# STATE OF VERMONT AGENCY OF TRANSPORTATION

## PROPOSED IMPROVEMENT TOWN OF SPRINGFIELD COUNTY OF WINDSOR PARK AND RIDE LOT

RECORD PLANS	
CONTRACTOR:	BAZIN BROTHERS TRUCKING, INC. - WESTMINSTER, VT
RESIDENT ENGINEER:	RYAN DARLING
CONSTRUCTION BEGAN:	MAY 4, 2015
CONSTRUCTION COMPLETE:	SEPTEMBER 25, 2015
RECORD PLANS BY:	RYAN DARLING & ELISE COOLBETH
I HEREBY CERTIFY THAT ALL THE CONSTRUCTION REQUIRED BY THIS SET OF DRAWINGS HAS BEEN ACCOMPLISHED AS INDICATED HEREIN.	
BY:	RESIDENT ENGINEER
DATE:	02/23/2017
NOTE: Any further information concerning final quantities, amounts or other details relative to this project may be found at Central Files in the electronic archives.

DIRECTOR OF PROGRAM DEVELOPMENT	
APPROVED:	DATE 6.25.17
PROJECT MANAGER : TINA BOHEL	
PROJECT NAME : SPRINGFIELD	
PROJECT NUMBER : CMG PARK (32)	
SHEET 1 OF 43 SHEETS

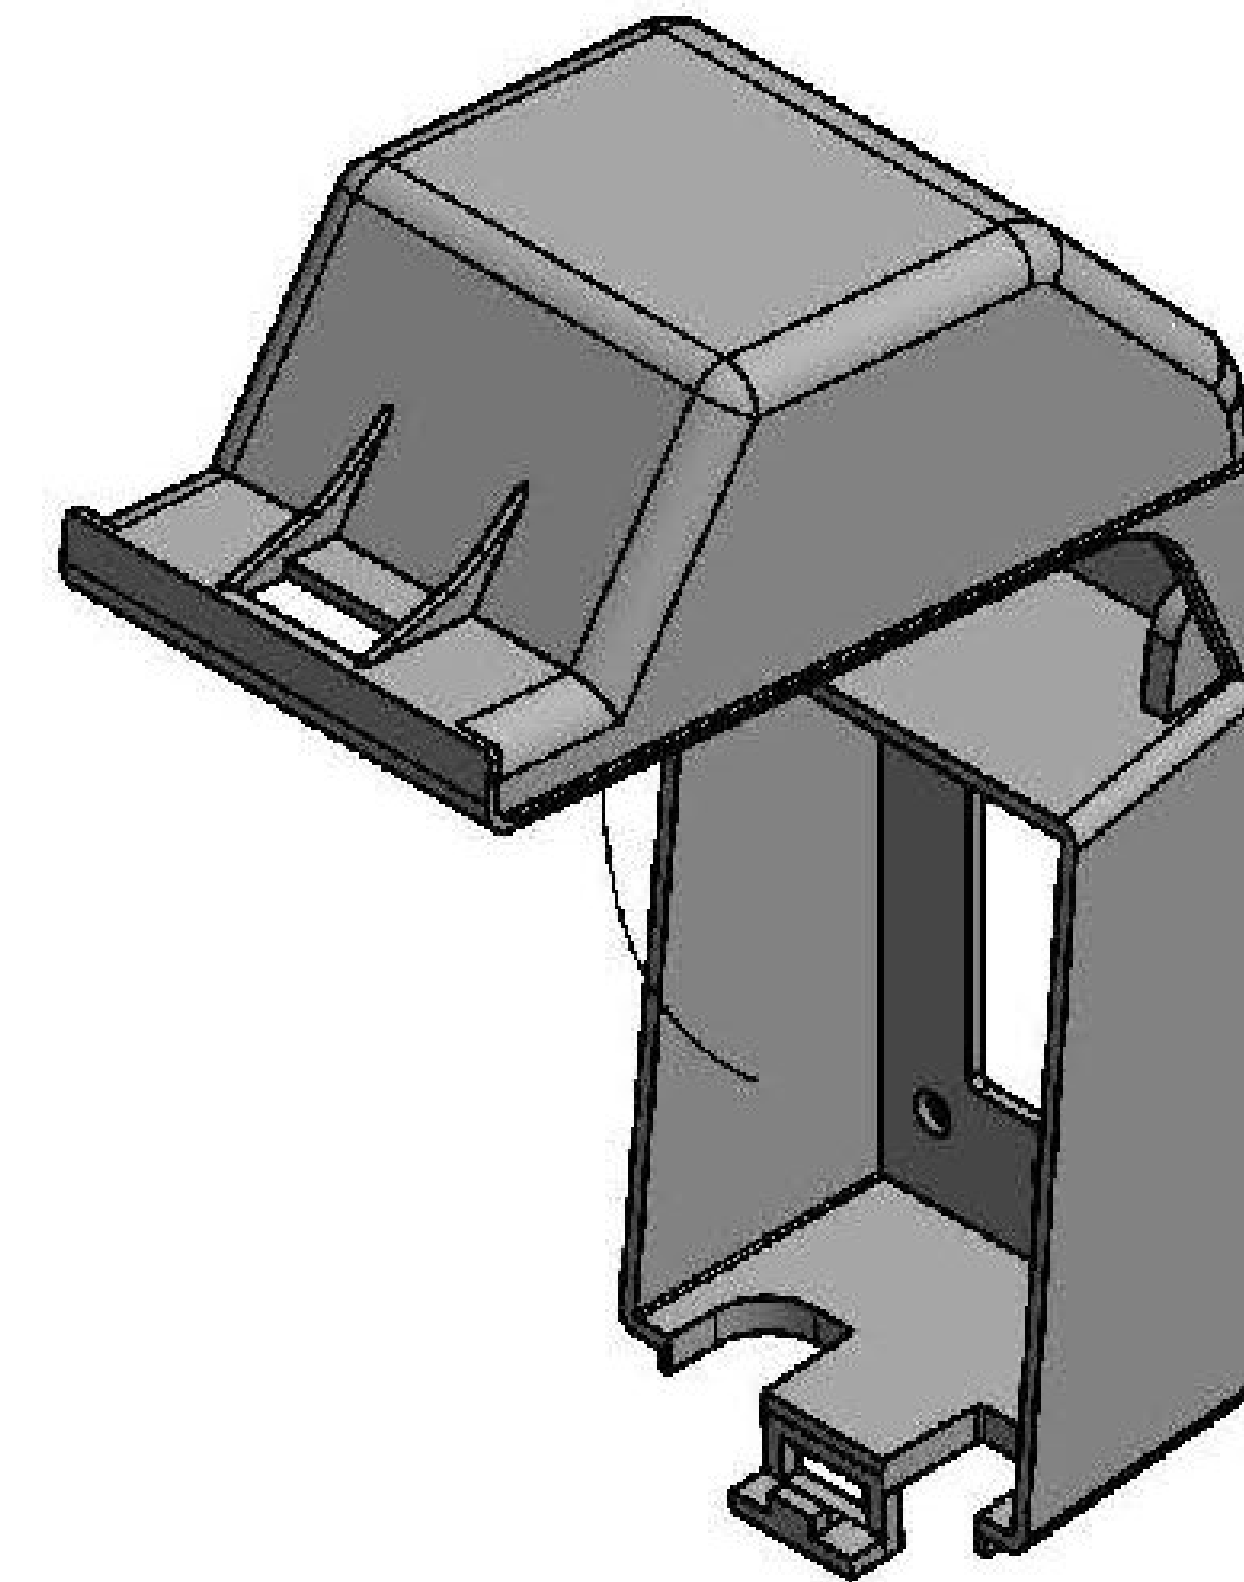
**FINISH: COVER SHALL HAVE A POLYESTER POWDER COAT FINISH TO MATCH POLE.** ✓
